DART AEROSPACE LTD		Work Order:	132349
Description: Crosstube Assembly, Mid Fwd		Part Number:	D206-667-147
Inspection Dwg: D206-667-147 Rev: A		Page 1 of 2

DART AEROSPACE LTD HAWKESBURY, ONTARIO, CANADA	
DRAWING NO. D206-667-147	REV. A SHEET 1 OF 4
TITLE CROSSTUBE ASS'Y (206L MID FWD)	SCALE NTS

DRAWING NO. D206-667-147	TITLE CROSSTUBE ASS'Y (206L MID FWD)	REV. A	DART AEROSPACE LTD ENGINEERING ORDER		D.E.O. NO. D206-667-147-A-1	SHEET NO. SHEET 1 OF 1	SCALE NTS
DRAWN <i>q</i>	CHECKED <i>AS</i>	MFG. APPR. <i>AS</i>	APPROVED <i>MD</i>		DE APPR. <i>MD</i>		
DATE 11.07.15	DATE 11.07.20	DATE 11.07.21	DATE 11.07.21		DATE 11.07.21

DRAWING NO. D206-667-147	TITLE CROSSTUBE ASS'Y (206L MID FWD)	REV. A	DART AEROSPACE LTD ENGINEERING ORDER	D.E.O. NO. D206-667-147-A-2	SHEET NO. SHEET 1 OF 1	SCALE NTS
DRAWN AJS	CHECKED	MFG. APPR.	APPROVED	DE APPR.		
DATE 12.08.02	DATE 12.08.02	DATE 12.08.02	DATE 12.08.02	DATE 12.08.02	DATE 12.08.02

DETAIL P
BONDING STRAP INSTALLATION 2 PL

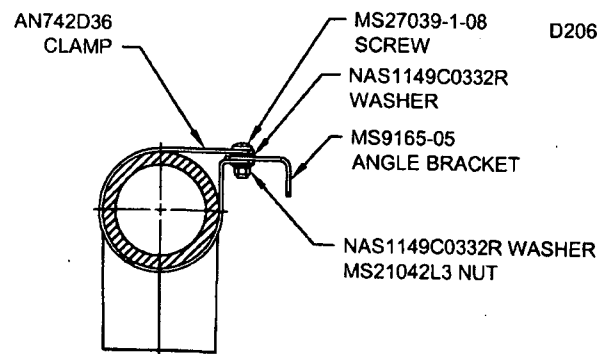
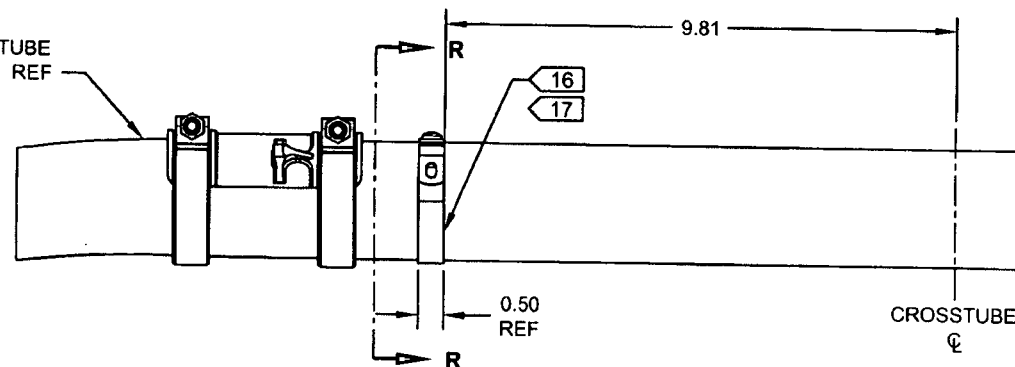
PURPOSE:

ADD ELECTRICAL GROUNDING STRAP

ITEM	QTY -147	PART NUMBER	DESCRIPTION	
1	X	D206-667-147	CROSSTUBE ASSEMBLY (206L MID FWD)	
10	2	AN742D36	CLAMP	] ADD
11	2	MS9165-05	ANGLE BRACKET	
12	2	MS21042L3	NUT (OR MS21042-3)	
13	2	MS27039-1-08	SCREW	
14	4	NAS1149C0332R	WASHER (OR AN960C10L)

- 16) MASK AREA UNDER CLAMP PRIOR TO PAINTING
 - 17) SEAL EDGES WHERE AN742D36 CLAMP MEETS WITH THE CROSSTUBE USING SIKAFLEX-241/291 OR MIL-S-8802 CLASS B2 OR PROSEAL 890 SEALANT
 - 18) PERFORM RESISTANCE CHECK TO ENSURE MAX RESISTANCE IS 10 MILLIOHMS
- AFT
